WESTERN SYDNEY AEROTROPOLIS DRAFT PRECINCT PLAN – NORTHERN GATEWAY PRECINCT

2143 – 2157 Elizabeth Drive, Luddenham

Northern Gateway Precinct Plan

Ecological & Riparian Assessment Report

Figure 2 The mapping of purported 'Existing Constraints' on the subject land at 2143-2157 Elizabeth Drive, Luddenham – contained in the *Draft Northern Gateway Precinct Plan*

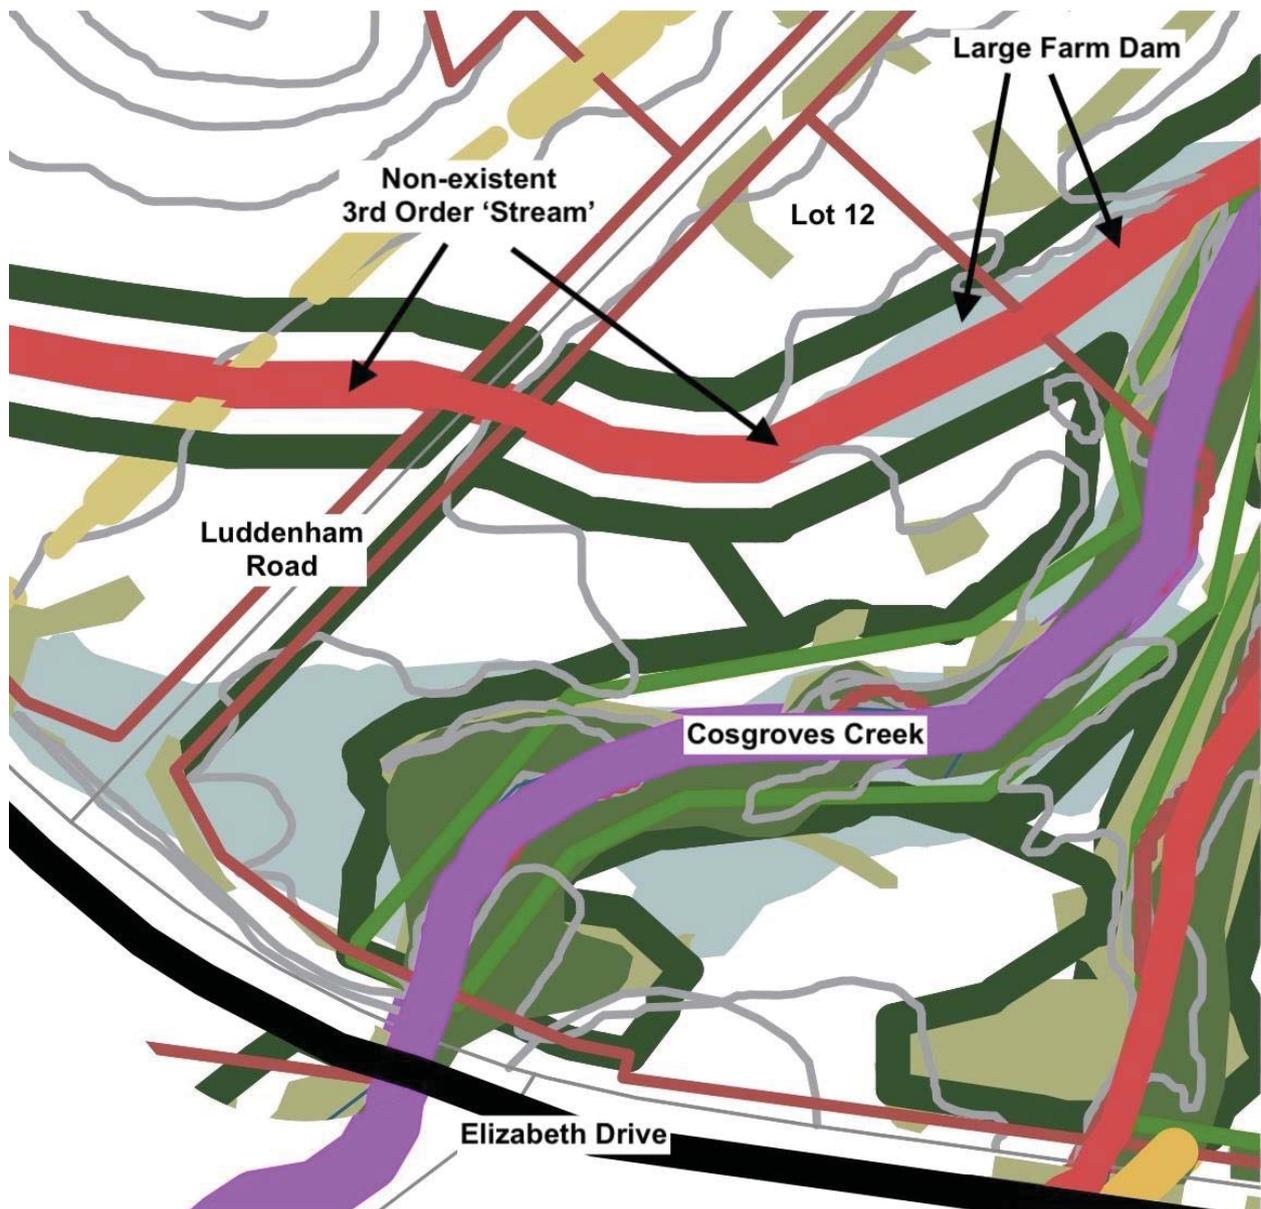
The mapping provided in the *Draft Northern Gateway Precinct Plan* of purported or alleged ‘constraints’ on the subject land at Luddenham (as noted above) is **coarse, inaccurate, incorrect and inappropriate**.

In the first instance, the lines used in the mapping are up to 20 metres in width. For a significant planning document, this is simply **unacceptable**.

Second, the lines are **inaccurate** and **incorrectly** placed (in part at least). For example, the dark green lines which purportedly define ‘*Cumberland Pain Conservation Plan Avoided Lands*’ identify an area substantially greater (approximately 120m in width) along Cosgroves Creek than those depicted in the *Draft Cumberland Plain Conservation Plan* (the ‘*Plan*’) – see Chapter 4 below). The mapping in the *Draft Northern Gateway Precinct Plan* is simply **inaccurate** and **incorrect**.

Further, the mapping of an alleged 3rd Order ‘Stream’ through the northern central part of the subject land is based on the **flawed** and **inaccurate** ‘Hydroline’ mapping of watercourses (see Chapter 5 below). There is no watercourse of any type at this location (see Photographic Essay in Attachment C); and this alleged ‘constraint’ simply **does not exist**.

As discussed above, the *Draft Northern Gateway Precinct Plan* mapping is **coarse, inaccurate, incorrect and inappropriate** – and **incorrectly** identifies the extent and/or presence of alleged 'Existing Constraints'.

The whole area occupied by the "Incorrectly mapped 3rd Order 'Stream'" in the extract from the *Draft Northern Gateway Precinct Plan* (Figure 2 above) is B – given that there is no watercourse of any type at this location (see Figure 1; Photographic Essay in Attachment C).

In addition, the mapping of the alleged 'constraint' along Cosgroves Creek is **excessive** and is **not consistent** with the *Draft Cumberland Plain Conservation Plan* (see discussion below).

Figure 3 The mapping of purported TECs on the subject land at 2143-2157 Elizabeth Drive, Luddenham – in the *Draft Cumberland Plain Conservation Plan*

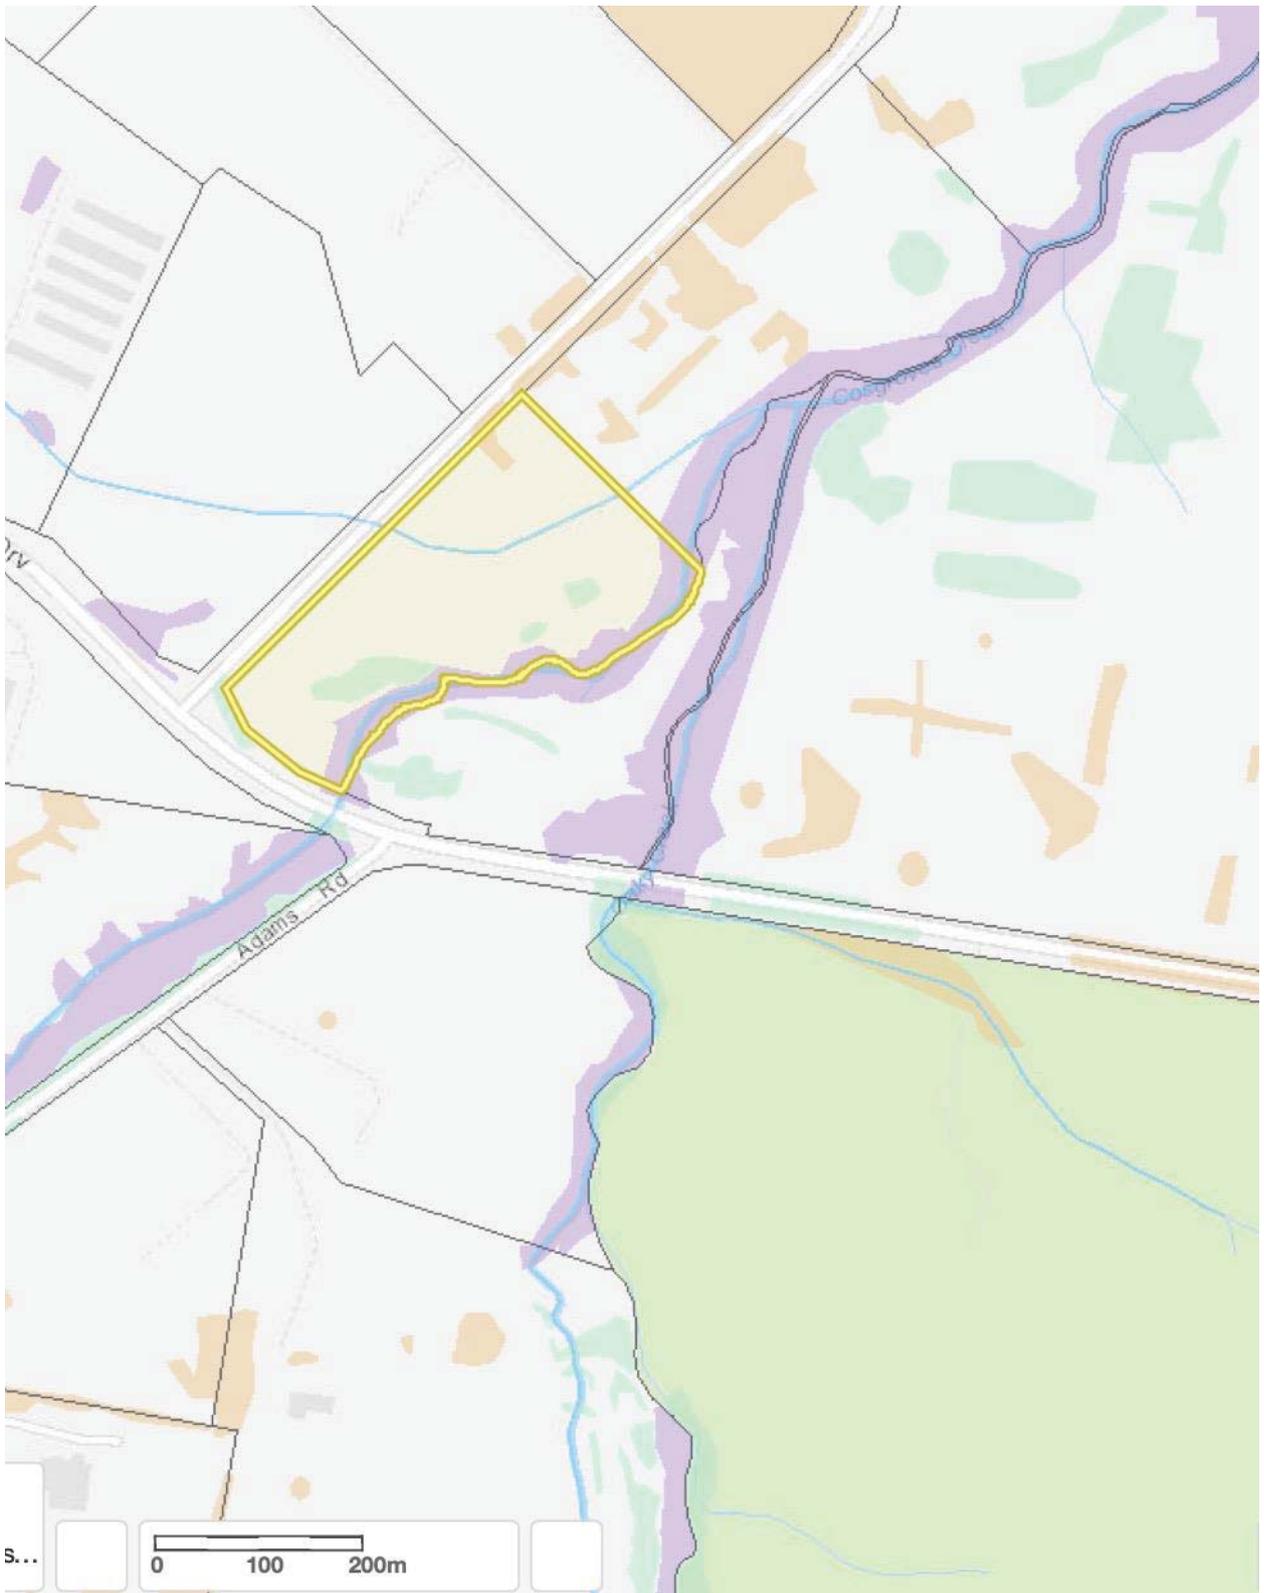
The mapping of vegetation contained in the '*Plan*' **does not** adequately or accurately reflect the existing circumstances on the subject land at Luddenham (see Figure 1 above and aerial photograph in Attachment A; Photographic Essay in Attachment C).

The vegetation along Cosgroves Creek is indeed dominated by casuarinas – and may constitute Swamp Oak Floodplain Forest (a TEC); although the *Casuarina* species has not been verified. The small patches of alleged River-flat Forest in the southeast of the subject land (near Cosgroves Creek) are actually stands of *Casuarina cunninghamiana* or *Casuarina cunninghamiana/glauca*. This is not a TEC.

The patches of alleged CPW in the north of the subject land are trees which were planted by the landowners over the last 60+ years – noting that some of the trees planted are species of the CPW community (albeit of unknown provenance and therefore not appropriately identified as a TEC).

These plantings are clearly **artificial**; and **do not** constitute the TEC. In addition, there is **virtually no** native understorey or groundcover – noting the presence of a dwelling with gardens and associated features, sheds, previously cleared lands, substantial stockpiles of equipment and materials, fences and tracks, non-native vegetation, extensive weeds and introduced plantings, and other artificial elements (see Photographic Essay in Attachment C).

There is **no evidence** that the mapping of any of the purported TECs on the subject land has been based on any site investigations. Indeed, given the inaccuracies documented above, it is clear that no proper verification of the vegetation on the subject land has been undertaken.

The mapping of TECs on the subject land at Luddenham is therefore **hypothetical** and **unverified**; and **cannot reasonably constitute a satisfactory basis** for precluding development on the land.

Figure 4 The mapping of ‘Proposed Environmental Conservation’ on the subject land at 2143-2157 Elizabeth Drive, Luddenham – in the *Draft Cumberland Plain Conservation Plan*

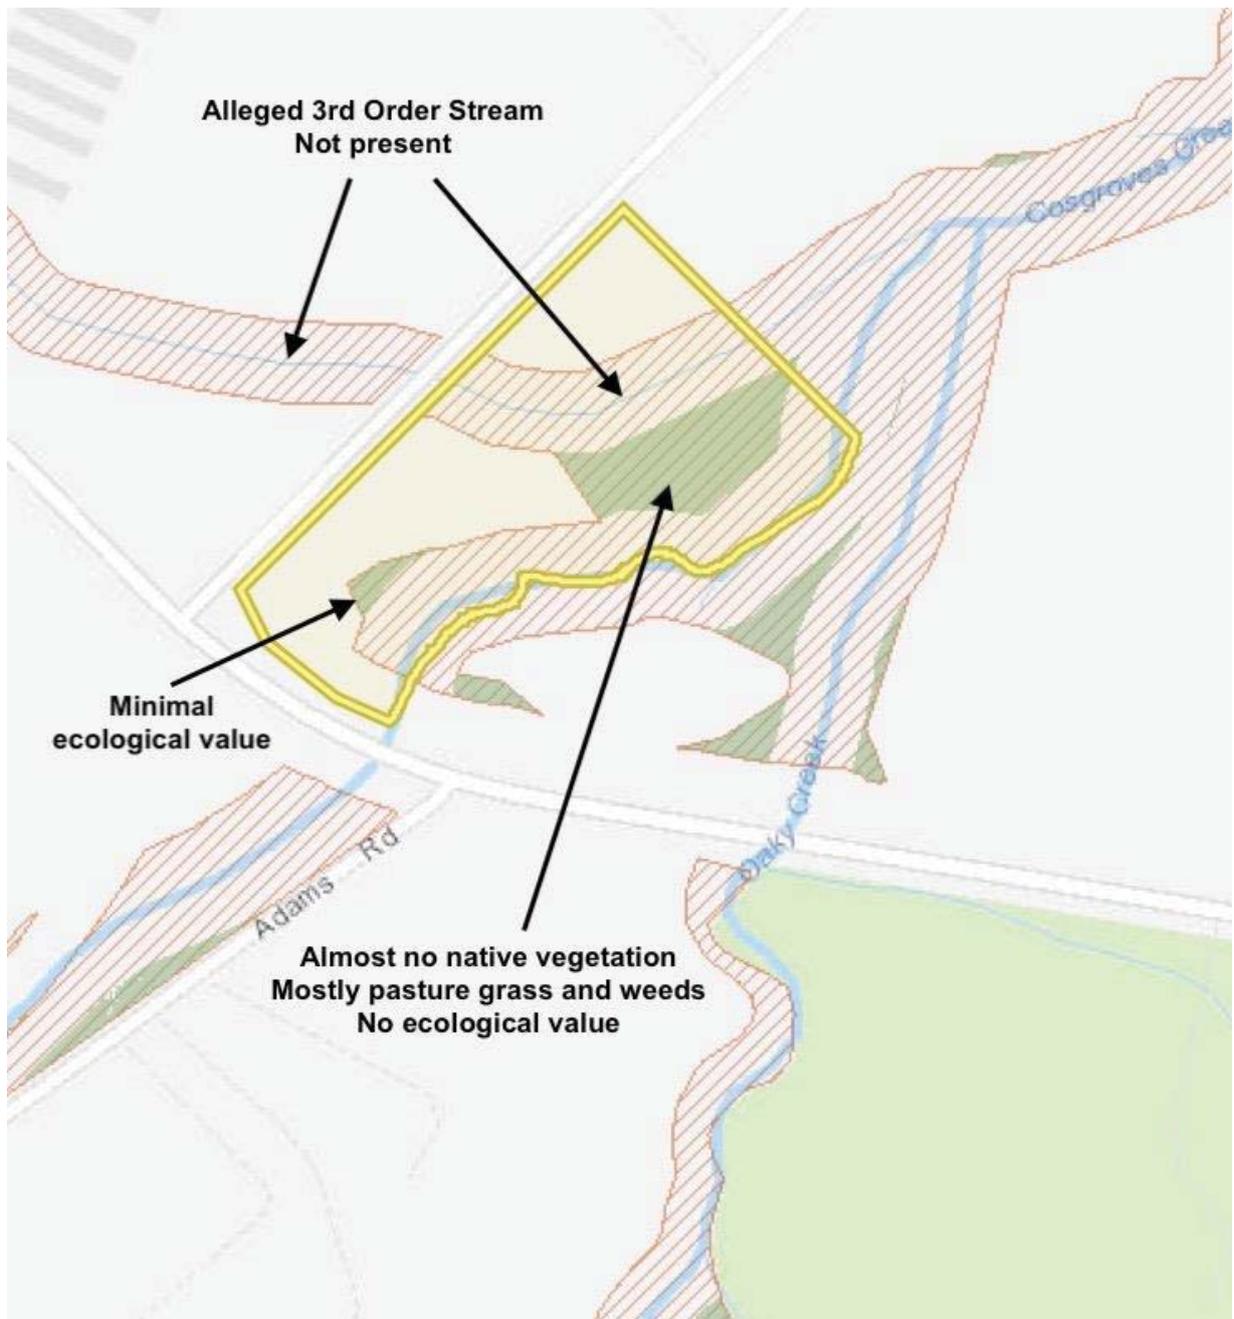
The mapping of a purported *Proposed Environmental Zone* along the non-existent purported 3rd Order ‘watercourse’ from the northwestern boundary of the subject land at 2143-2157 Elizabeth Drive, Luddenham through the centre of the land is **entirely inappropriate**.

As discussed in detail below (Chapter 5), there is **no** such ‘watercourse’ (or ‘creek’ or ‘stream’) at this location (see Figure 1 above and in Attachment A; Photographic Essay in Attachment C). This is merely an overland flow path (with no channel or even a simple invert) and a large farm dam; surrounded by a paddock of introduced pasture grasses and weeds. There is **no native vegetation** at this location on the subject land.

There is **no conceivable justification** for this portion of the purported *Proposed Environmental Zone* on the subject land at Luddenham as mapped in the *Draft Cumberland Plain Conservation Plan* - on ecological or riparian grounds.

Similarly, the patches of ‘vegetation’ on the subject land identified as “*Non Certified - Avoided for Biodiversity*” (see Figure 4 below: Attachment A) are **completely unjustifiable** on ecological grounds.

The larger patch between Cosgroves Creek and the **non-existent** ‘watercourse’ (from the northwestern boundary of the subject land) contains virtually **no** native vegetation – being dominated by introduced pasture grasses and weeds (see Figure 1 above and in Attachment A; Photographic Essay in Attachment C). The smaller patch is partly (although not accurately) coincident with small stands of *Casuarina cunninghamiana* or *Casuarina cunninghamiana/glauca* – of very **extremely low** biodiversity conservation value or potential.

Orange Shading Proposed Environmental Conservation area – despite the criticisms documented above

Light Green Identified “*Non Certified - Avoided for Biodiversity*” – despite the lack of any biodiversity values in this area

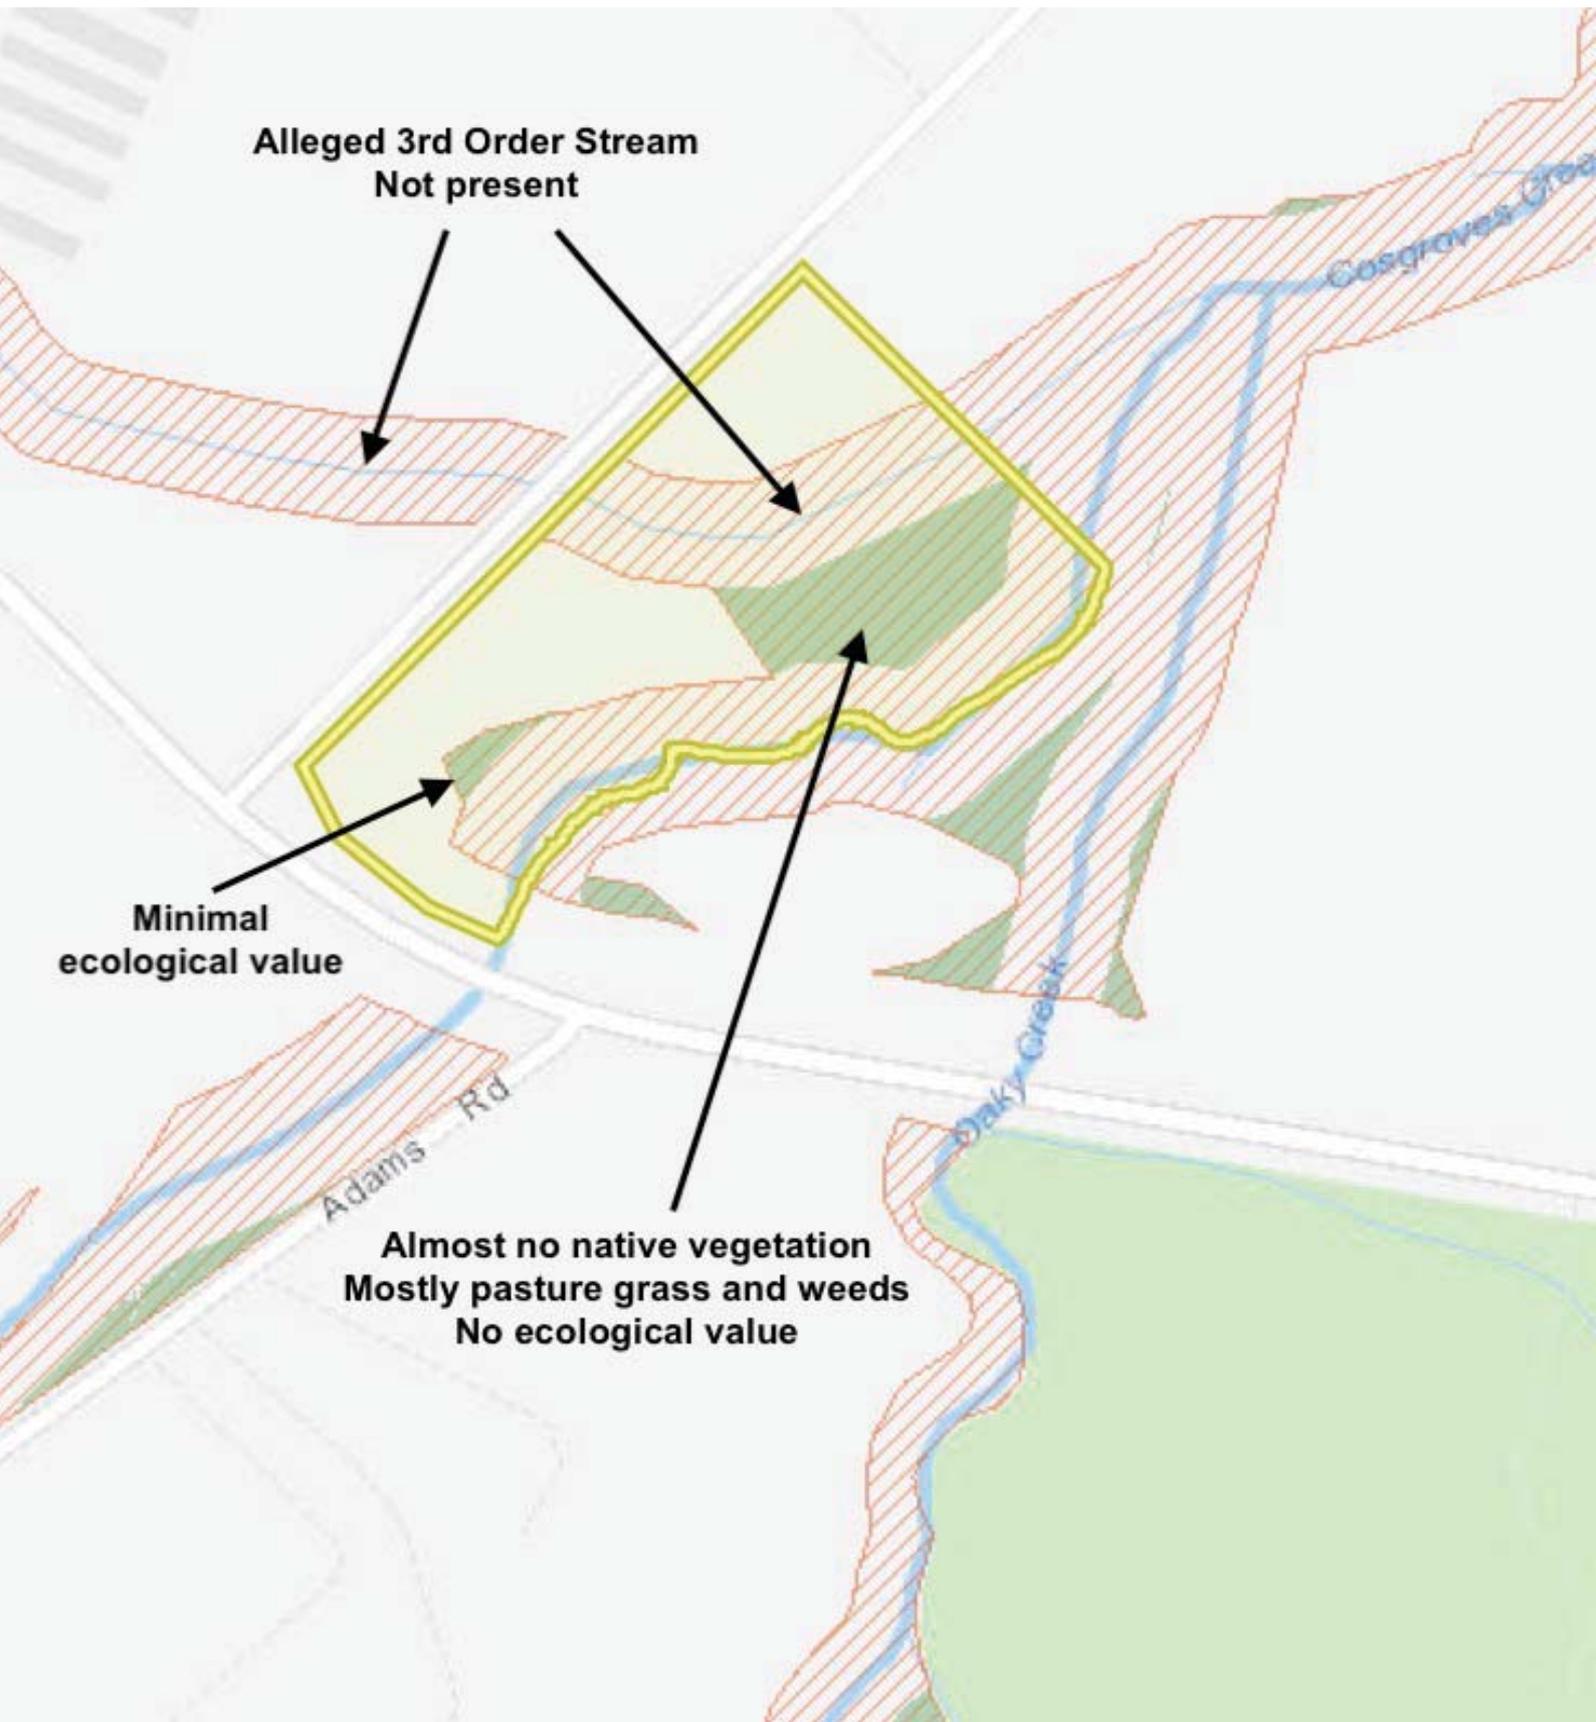
**Alleged 3rd Order Stream
Not present**

**Minimal
ecological value**

**Almost no native vegetation
Mostly pasture grass and weeds
No ecological value**
